September 3, 2021

Mr. Doug Anderson  
Program Director – Energy Star Windows  
US Environmental Protection Agency

The ENERGY STAR Windows version 7 criteria analysis and report are technically flawed in the usage of "equivalent" and "energy savings" in that disparate energy streams (gas and electric) are added directly at site. This violates two of the guiding principles listed on page 4 of the report:

Graph 1

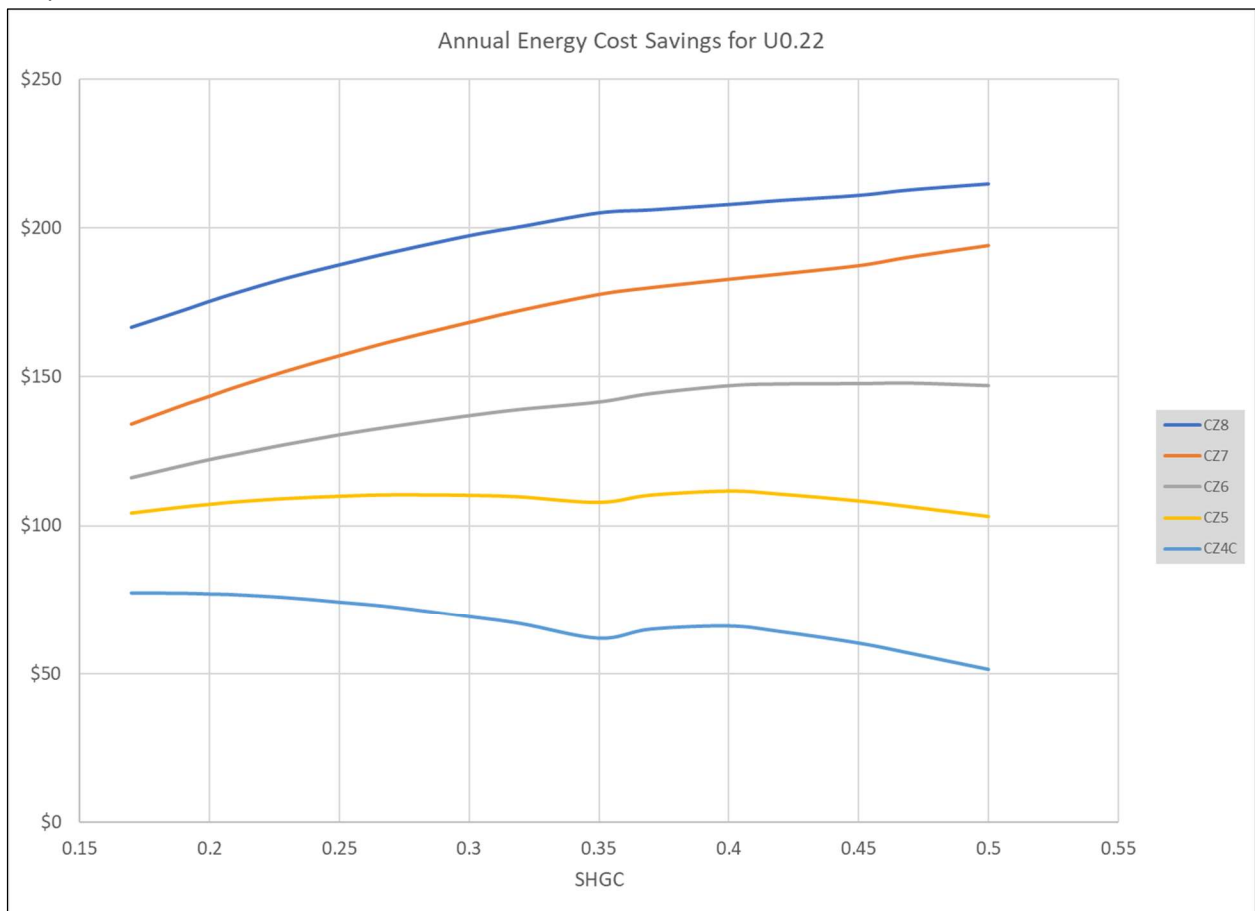
Graph 1 (next page) plots the annual energy savings (market baseline) for each climate zone in Northern as presented in the spreadsheet *WDS\_V7\_Draft 1 Data3a - Results and Assumptions*. Note these dollars are based on the ENERGY STAR energy price assumptions presented in Table 9. We'll use this data as presented but it's my contention that energy prices should be local (state level) and consider time of year pricing fluctuations.

The different slope/direction of each zone line says that the proposed grouping of climate zones 4C through 8 into Northern is wrong.

- The upward slope of the climate zone lines for 6, 7, and 8 suggest a passive benefit with high solar gain (more on this later).
- Climate Zone 6 is about 89% of the population in CZ6-8 and as such will dominate any discussion on potential solar trade-up in this region.
- The slope of the line for climate zone 5 is flat: no change in consumer cost regardless of SHGC (equal cost trades between gas heating and electric cooling).
- The flat line for CZ5 is consistent with the 2021 update to the IECC which set a 0.40 SHGC maximum for the zone. Note to EPA: this update to the 2021 code was missed in the code development discussions.
- The downward slope (reduced savings) in CZ4C reinforces the SHGC cap for zones 5 and 4C.

The “bump” in the profile at SHGC around 0.35 is from a modeling error in the Energy Plus program for all versions prior to 9.4 (including version 8.9 used in this analysis). For more background on this see this link: [Fix issue where simple glazing system had negative absorptance at some incident angles by nealkruis · Pull Request #8001 · NREL/EnergyPlus · GitHub](#). Note that this update to Energy Plus occurred after the ENERGY STAR modeling was run.

This negative absorptance error led to an over-estimate of heating loads, on the order of 2%, and an under-prediction of cooling that varies by climate zone (from 3% in the south to >10% in the north).

Graph 2

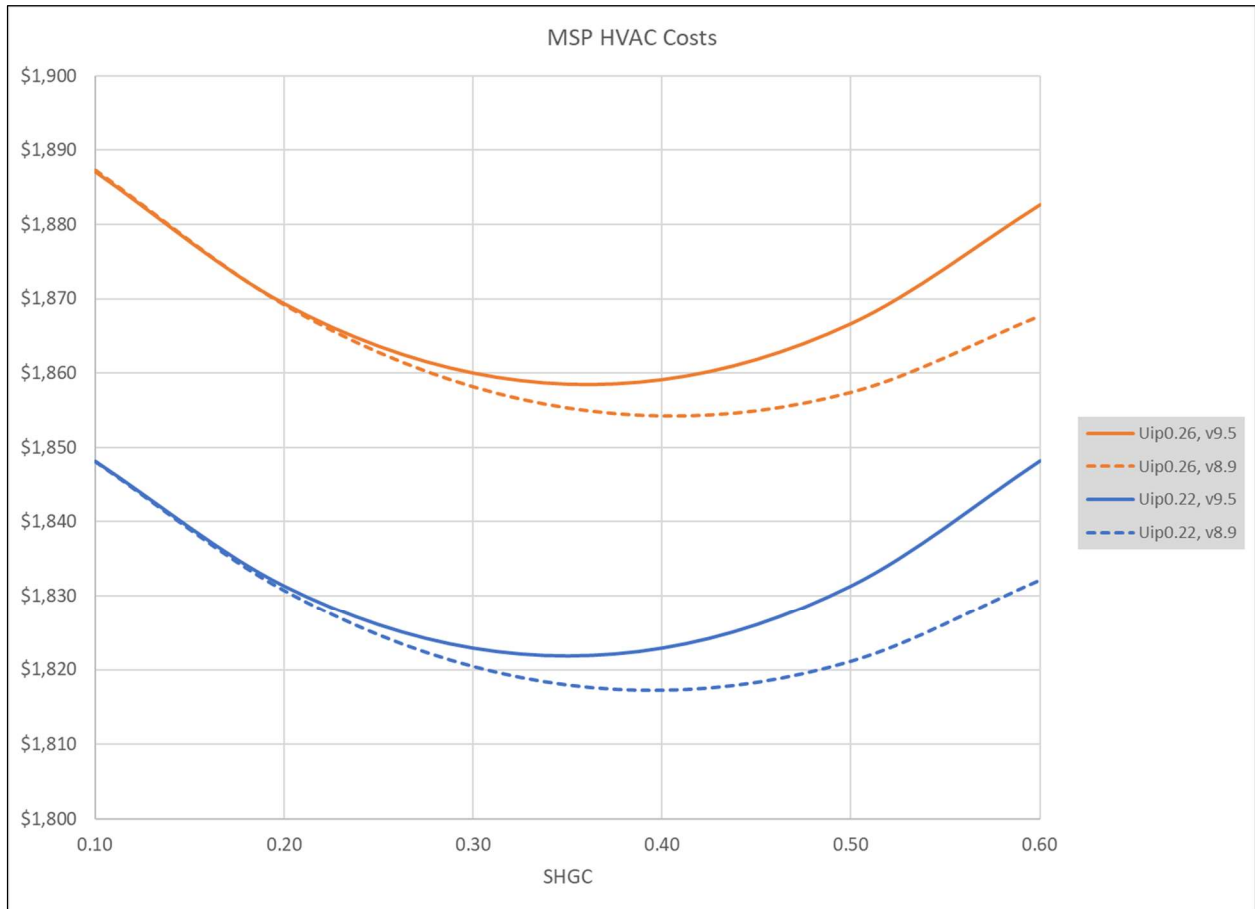
Graph 2 is a visualization of the change in HVAC energy costs as a function of SHGC in Minneapolis with the error correction. Note: these trends were developed from E+ runs I did on (121) window U and SHGC combinations for (1) archetype (gas furnace, slab-on-grade). Percentage wise the modeling change isn't of huge consequence, but the slope of a potential trade-up line will be flatter than the Version 7 Draft (uncorrected) data suggests.
